Response to City of Garden City Design Review Committee Comments:

- A.** DSRFY2019-7 - JOSHUA HERSEL WITH CTA ARCHITECTS ENGINEERS IS REQUESTING DESIGN REVIEW APPROVAL OF A NEW INDOOR POOL FACILITY AND RELOCATING AN EXISTING FITNESS AREA AND GUEST LAUNDRY AT THE RIVERSIDE HOTEL. THE 13.52 ACRE SITE IS LOCATED AT 2900 W. CHINDEN BLVD., GARDEN CITY, ID 83714; ADA COUNTY PARCEL R2734541990.

RIVERSIDE HOTEL POOL/FITNESS

DR201

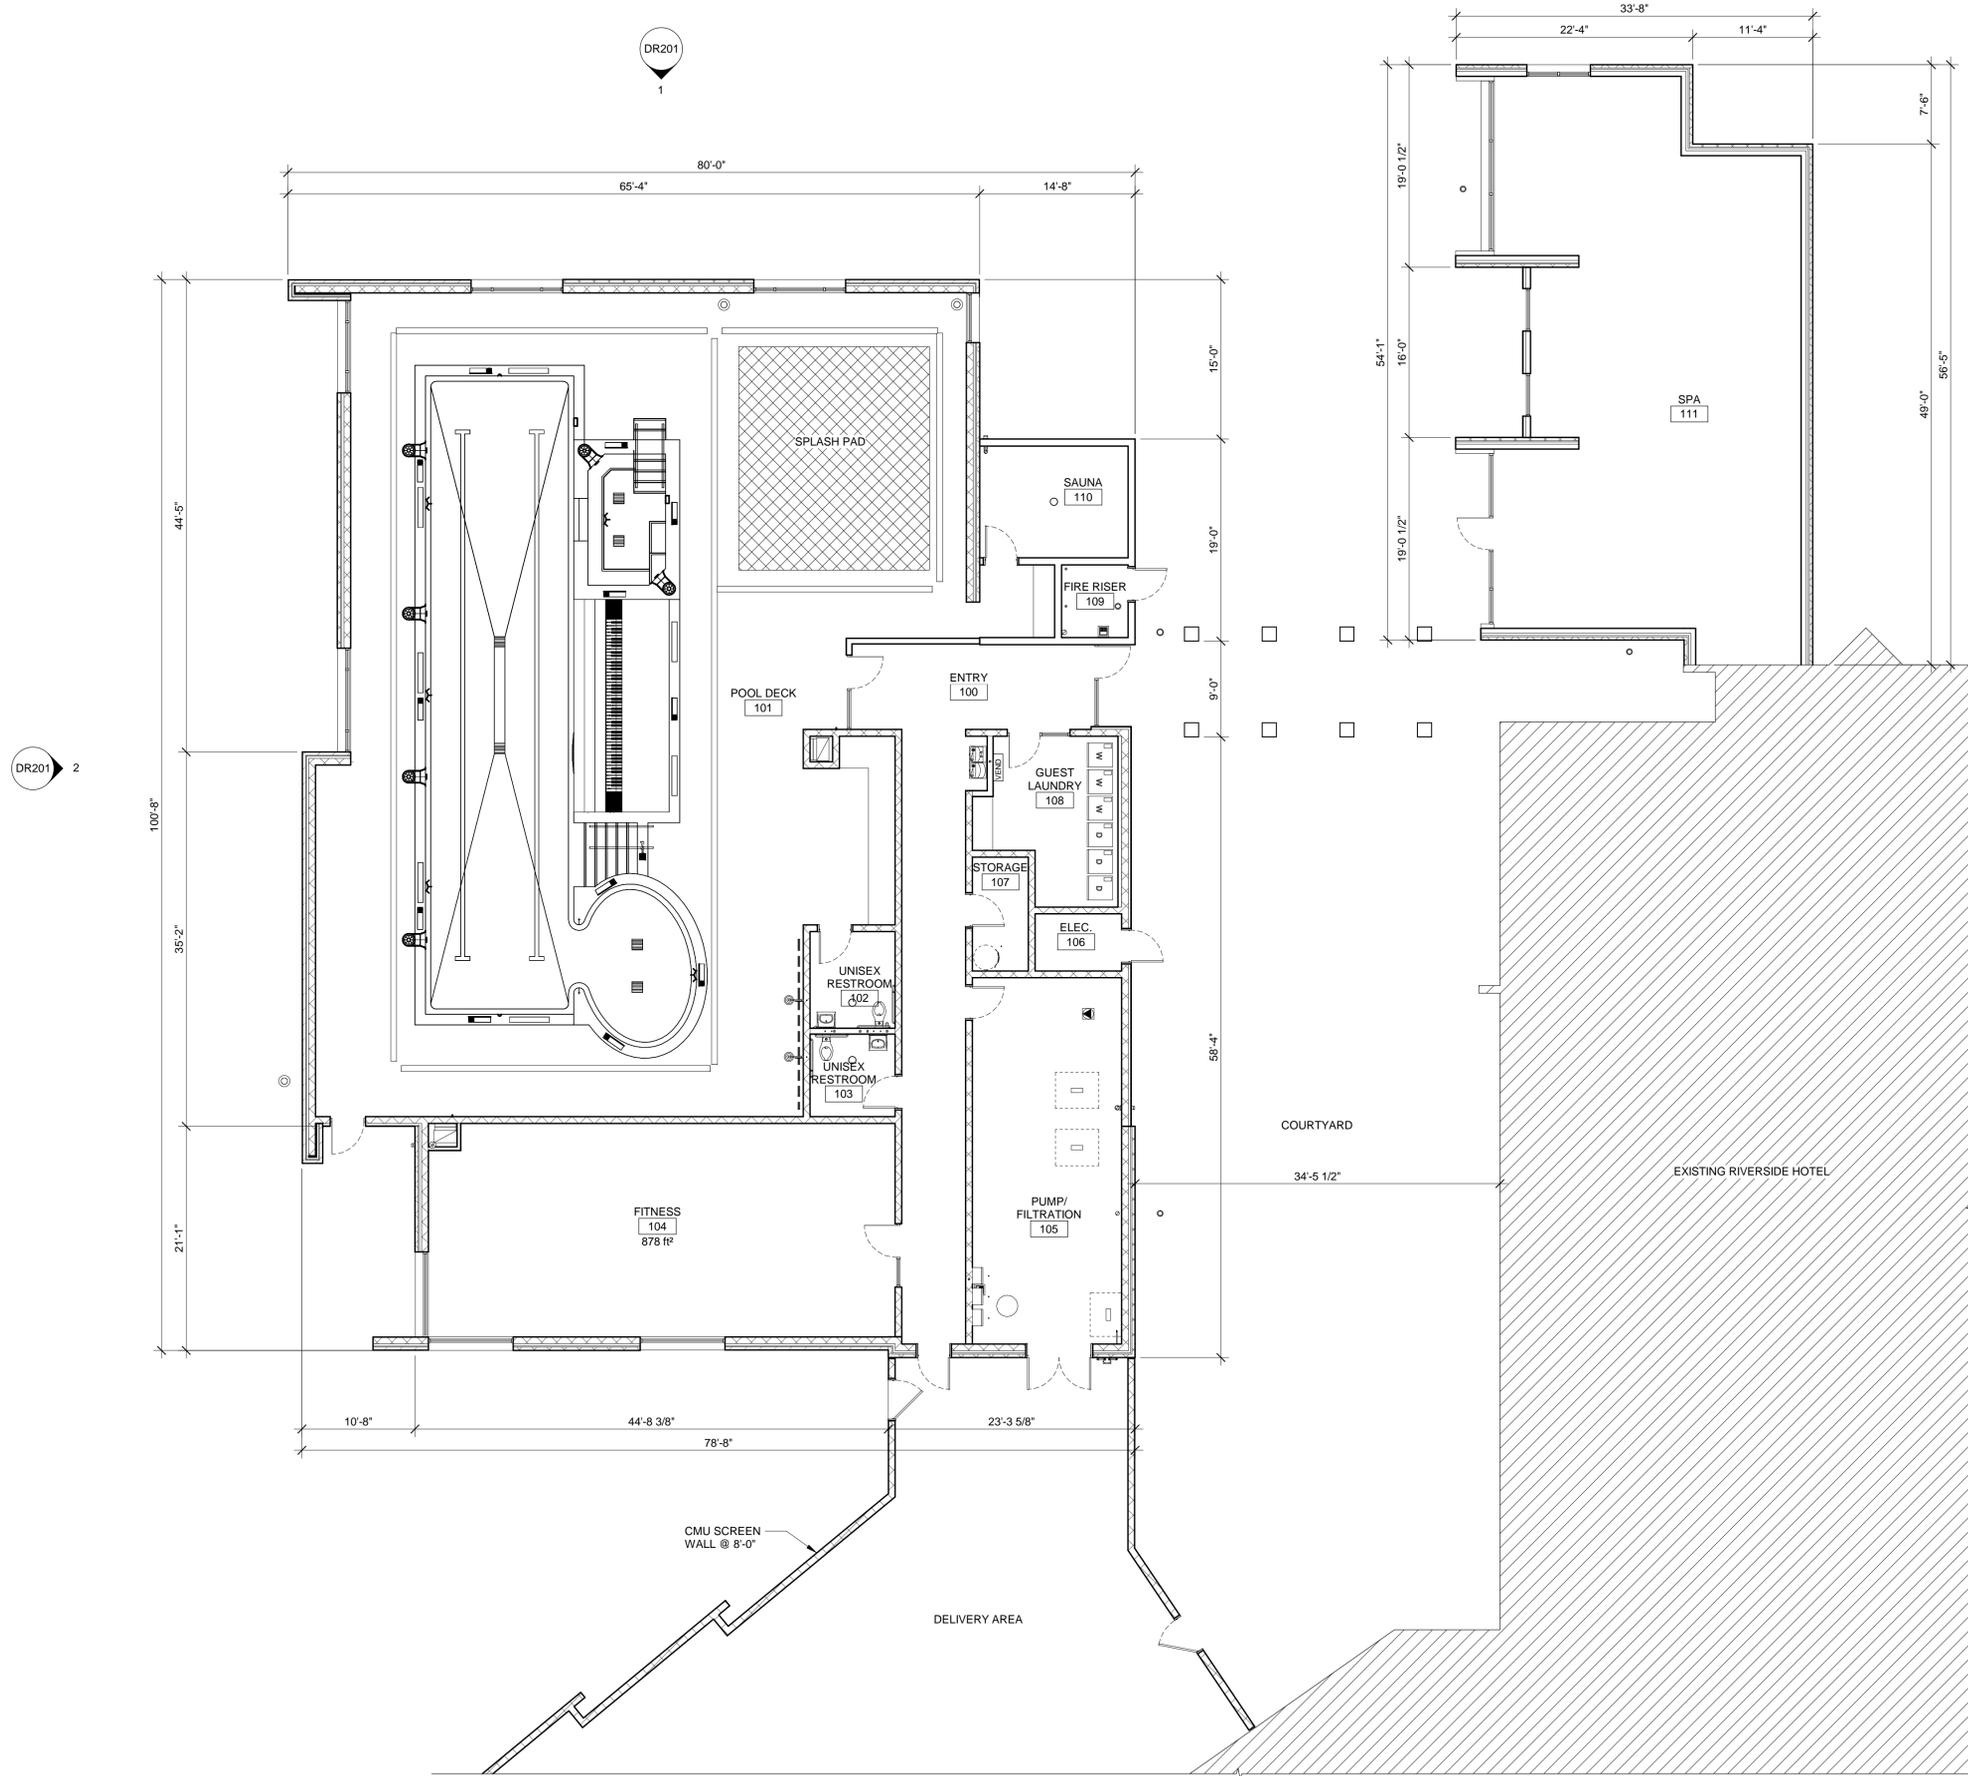
3. Consider the placement of the walls around the loading area and the effect of their presence.

4. Height of wall is needed.

7. Outside screening needs to be addressed.

Response: The height of the screen walls has been taken into consideration. The height has been lowered from 10'-0" to 8'-0" to still provide desired screening of back of house utilities. An image of the existing facade is included on the DR201 to illustrate why a screened wall would improve the appearance of this area.

Response: The screen wall height was called out on sheet DR201. This sheet has been updated with the new height of

8'-0" at the delivery zone and 6'-0" at the transformer/
generator location.

Response: The CMU screen walls are intended to have a
variegated texture which captures light and shadow. See
example images of this texture on DR201. Tall grasses/
plantings will be incorporated with the CMU walls for an
aesthetically pleasing appearance.

LANDSCAPE PLAN

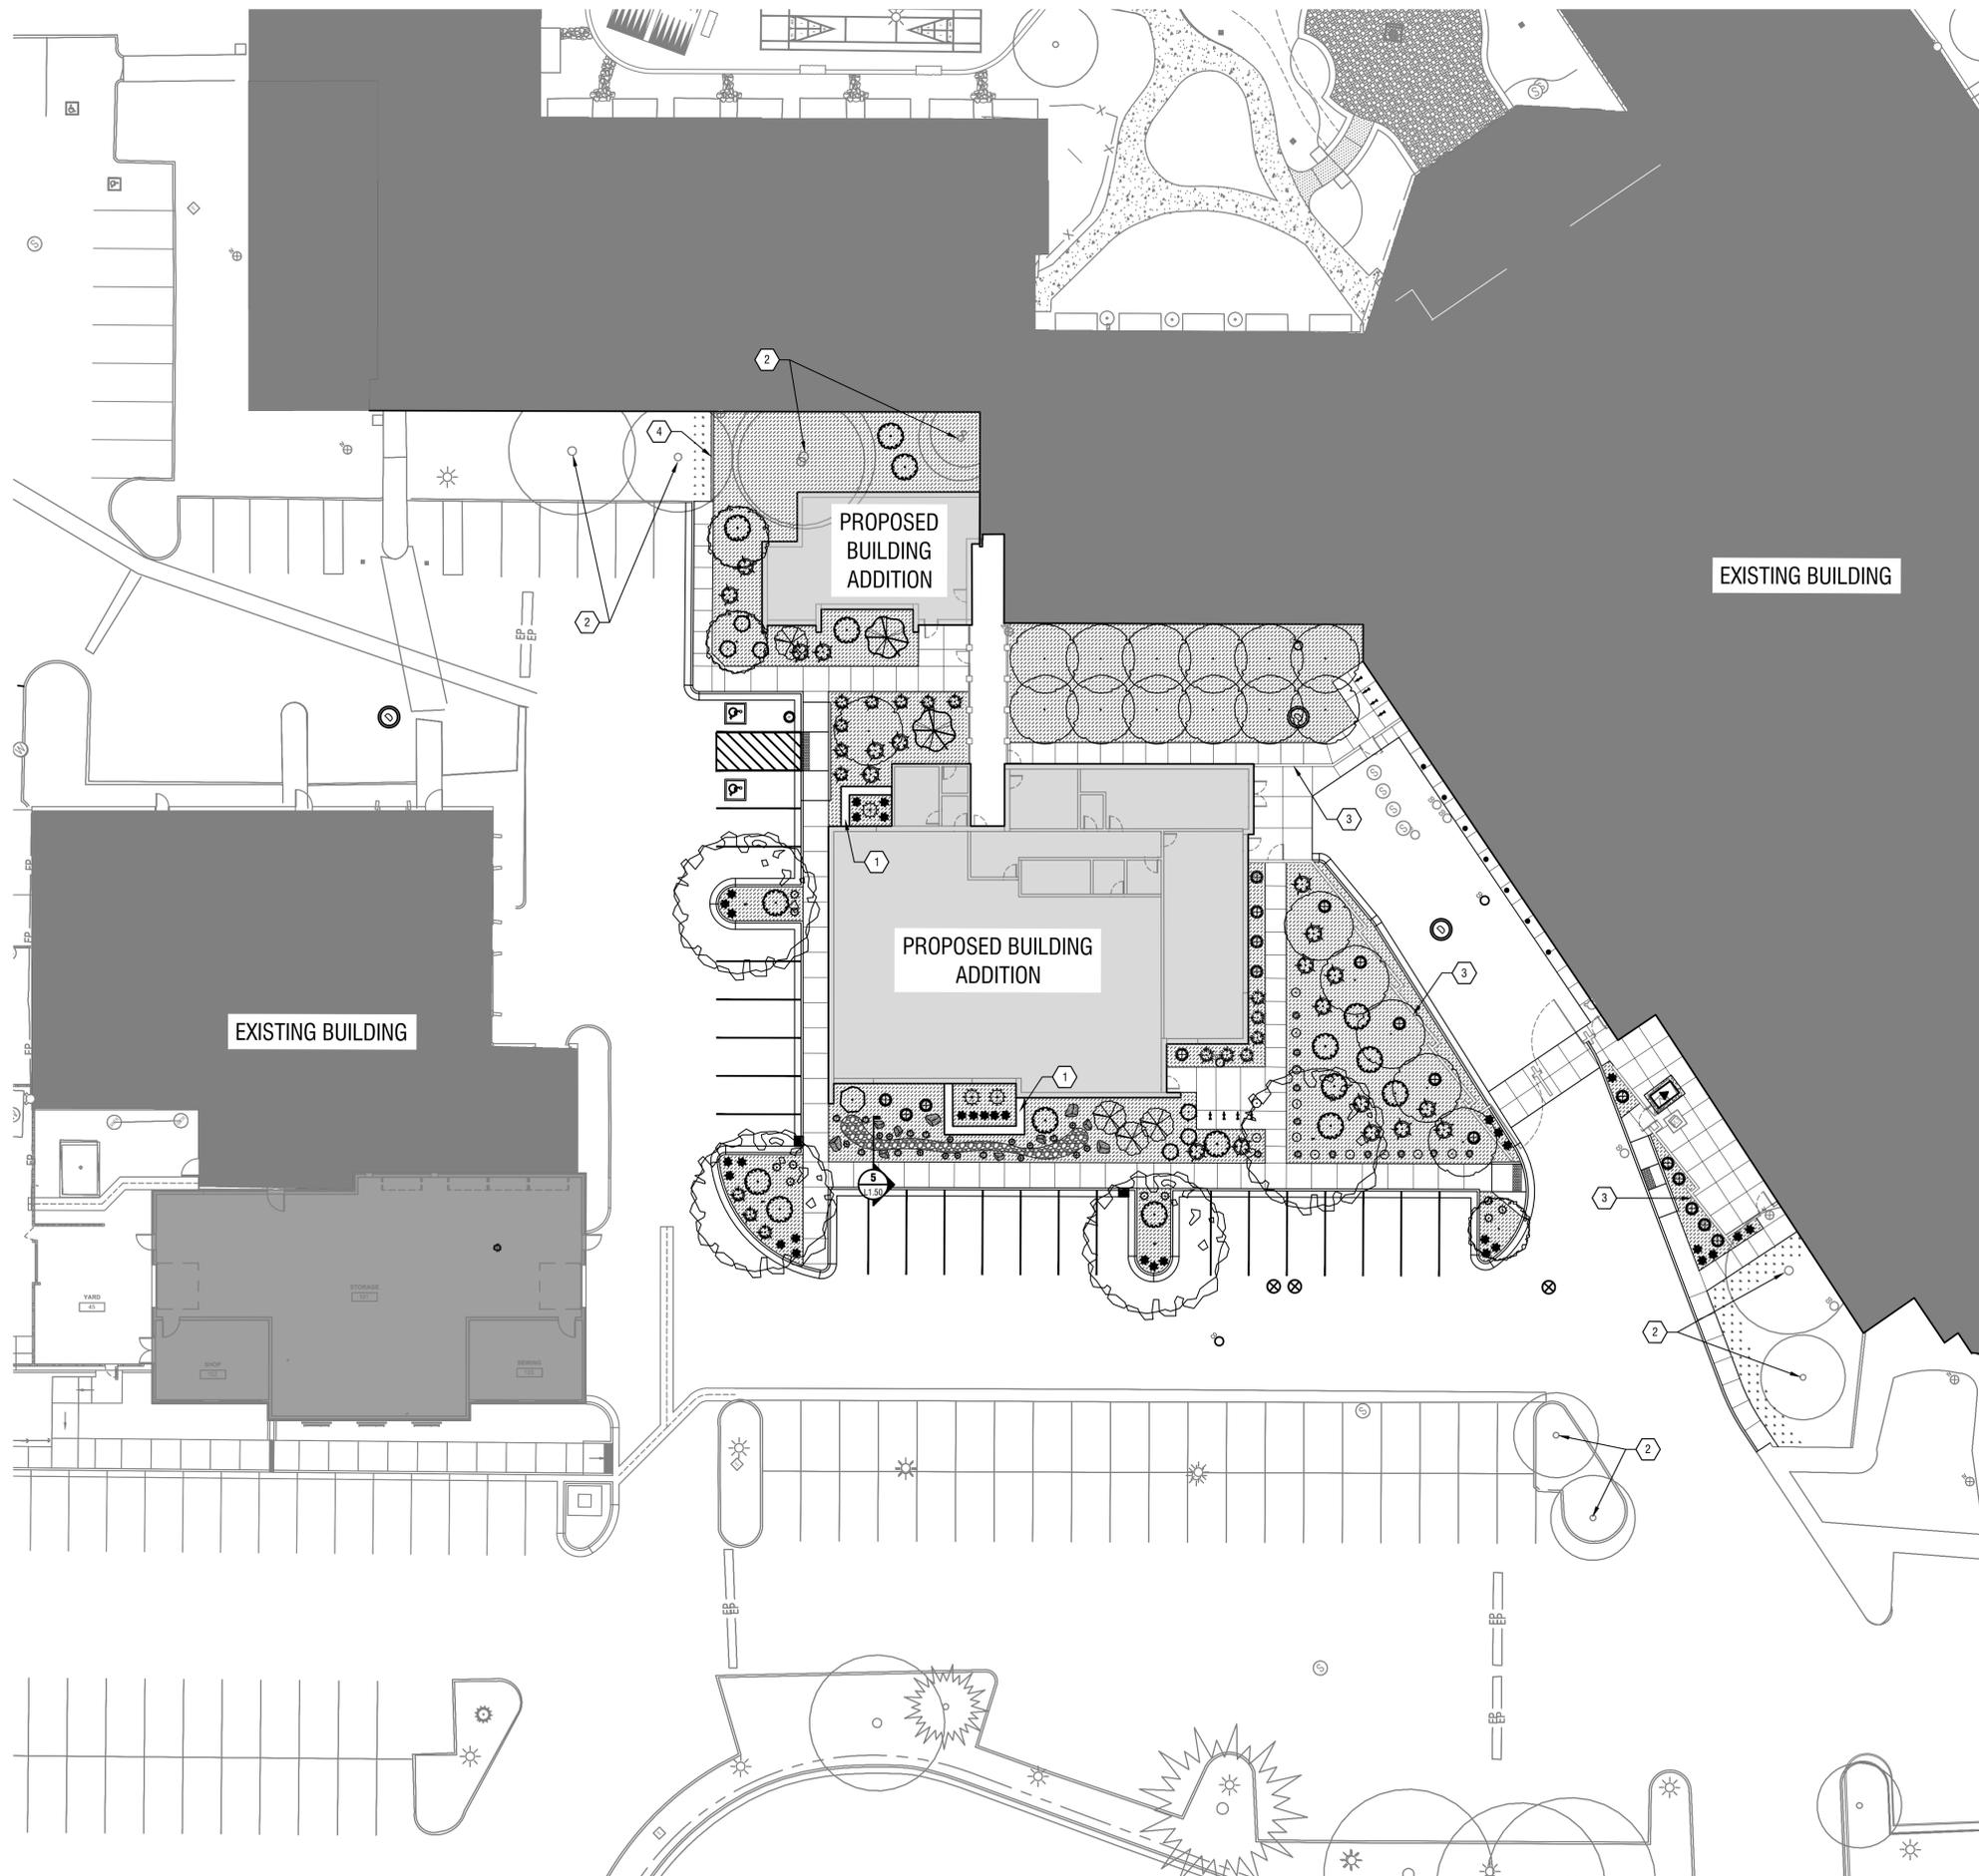
5. Canopy coverage square footage is needed.

6. Bicycle parking for guests needs to be addressed.

Response: Re: updated landscape drawings and attached
letter of explanation.

Response: Re: updated landscape drawings with bicycle
parking included.
